Product Change Notification

Product Change #: PCN382

Description of Change:

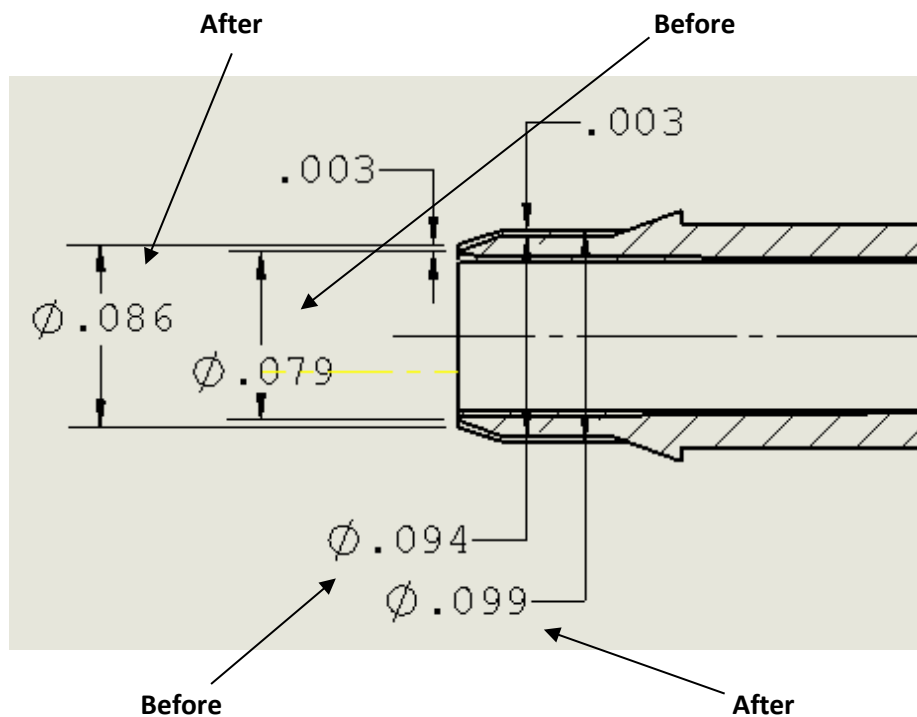
N430/420 (reducers) parts will have a change to the through hole diameter to enhance flow; this correspondingly results in a slight change to the 420 barb geometry as depicted in the image below.

Reason: Flow enhancement

Parts Affected: N430/420-1, N430/420-2, N430/420-6005,
N430/420-6012, N430/420-J1A

Implementation Procedure: Samples will be available starting May and this product will experience a rolling change with traceability through lot numbers. Old part will be obsoleted after depletion of inventory. Updated engineering drawings will be available on our website.
